REPORT AMENDED BY STAFF & CPC 3-8-90
REPORT AMENDED BY STAFF 2-14-90
CITY PLANNING COMMISSION
1231 "I" STREET, SUITE 200, SACRAMENTO, CA. 95814

- APPLICATION:**
- A. Negative Declaration
 - B. Amendment to Pocket Community Plan to allow back-up lots adjacent to the Sacramento River Parkway and reduce the 40 foot levee easement to 20 feet
 - C. Rezone of 9.7+ partially developed acres from Agriculture (A) zone to Standard Single Family (R-1) zone
 - D. Tentative Map to divide 9.7+ partially developed acres into 19 23 single family, 8-halfplex lots, and one lot to be dedicated to the City for parkway (amended by staff)

APPLC. NO. P89-158

TENTATIVE SUBDIVISION MAP
CARRIAGE ESTATES
 City of Sacramento, California

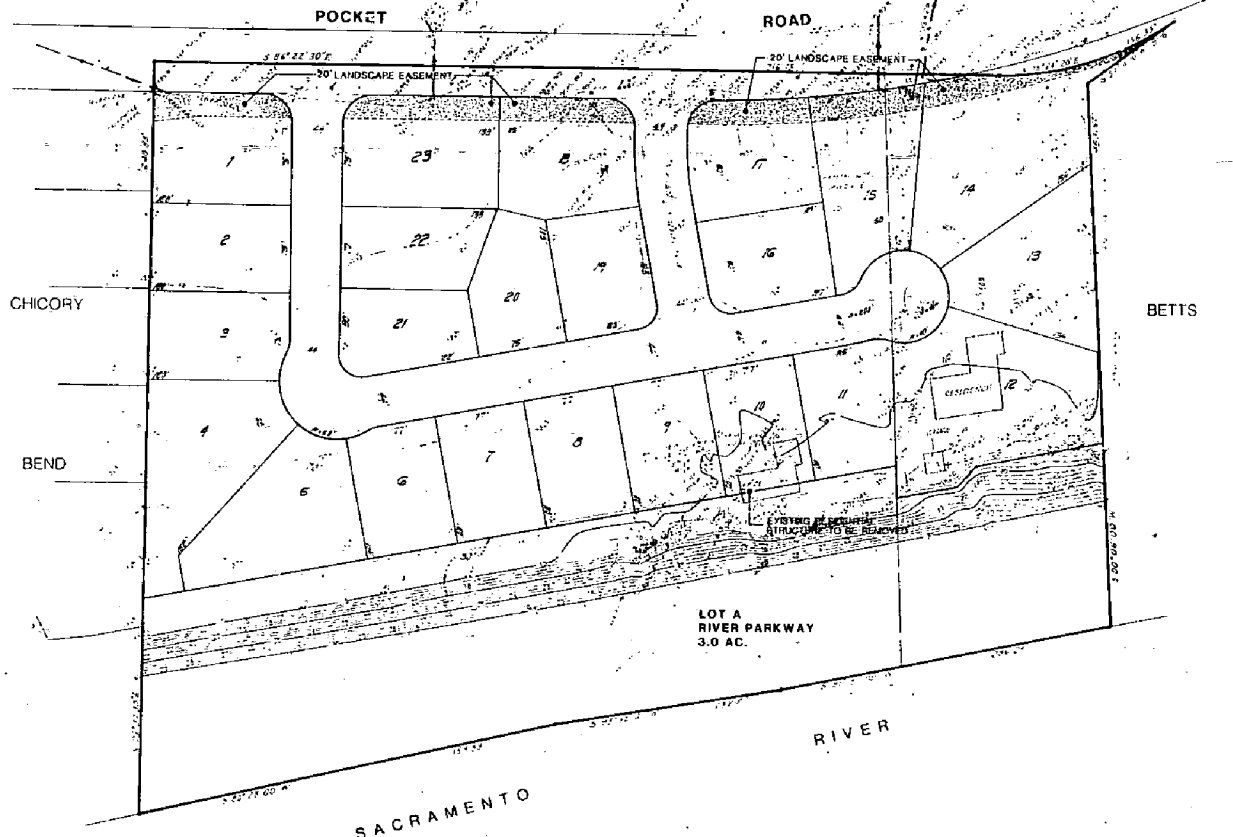
Staff can find no compelling reason to establish a precedent in amending the plan. Staff recommends that the proposed tentative map be denied and that the map be redesigned and resubmitted showing a lotting pattern similar to Exhibit D reflecting elimination of back-on lots and providing a 30 foot levee landscape parkway.

The proposed tentative map shows a total of 28 24 lots with 19 23 standard single family lots, 8 halfplex lots and one Lot A to be dedicated to the City of Sacramento as part of the Sacramento River Parkway. ~~No plans were submitted for the halfplex units.~~ Lots 6 to 13 are back-on lots to the parkway with a 20 foot landscape and levee maintenance easement shown from the toe of the levee to the rear property line of the lots. Lot 13 is proposed to retain the Silva family residence. The dwelling on Lot 11 is to be

Staff does not support the map design as previously stated based upon comments received from the Parks Department, Exhibit C, and inconsistency with the Pocket Community Plan. The applicant has provided arguments for the proposed map and has provided 5 conditions acceptable to his client if the tentative map is approved (refer to Exhibit E).

Access onto Pocket Road is restricted from each of the proposed halfplex lots due to a 25 foot landscape parkway adjacent to Pocket Road. No driveways to halfplex units are allowed off Pocket Road. A joint driveway from the interior streets shall provide access to both units. Absent detailed elevations and floor plans, staff recommends Planning Director review of halfplex units prior to issuance of building permits.

The applicant has also proposed 10 feet of landscaping adjacent to Pocket Road as a continuation of LPPT Parkway. The original tentative map for Carriage Estates showed a 25 foot wide landscape parkway adjacent to pocket Road. A green belt adjacent to Pocket Road has been installed adjacent to the subject site which ranges in width from 6 feet to 20 feet. This appears to have been installed at the time street improvements were constructed. Portions of the existing turn-out and curb, gutter and sidewalk adjacent to the site will require removal and redesign. Staff would recommend continuation of the 25 foot wide parkway adjacent to Pocket Road as shown in the original tentative map.

With the above considerations in mind, the Planning Division staff and Parks and Recreation Department staff recommend denial of the proposed tentative map and advise the applicant to redesign the map to comply with the policies and goals of the Pocket Community Plan, Sacramento River Parkway Plan, and the treatment to Pocket Road as stated in the LPPT PUD Guidelines.

14. Show a 20 30 foot parkway easement from the toe of the levee. Show toe of levee on final map; *(amended by staff)*
15. Dedicate the southwesterly 5 feet of Lot 14 as a public utility easement for underground electrical and public utility facilities and appurtenances;

23. Eliminate the meandering lot line on parcel 13 and replace with a boundary line more easily described in a legal description;

31. If and when the Silva residence currently located on lot 13 is removed from lot 13, the owner of lot 13 shall sell an additional ten (10) foot strip on the levee side of lot 13 for the same price as the unencumbered portion of the property behind lot 13 was sold to the City. (Added by staff)
32. 31. A decorative masonry wall fence shall be reviewed and approved by the Planning Director for those lots adjacent to Pocket Road. Design and color of the six foot high wall shall be compatible with similar walls along the Pocket Road Parkway. (amended by staff)
- *33. Subdivider shall provide a 20 foot landscaped easement parallel to the City right-of-way. (staff added)
- *34. The map shall be redesigned to provide public access to the Sacramento River. (CPC added)
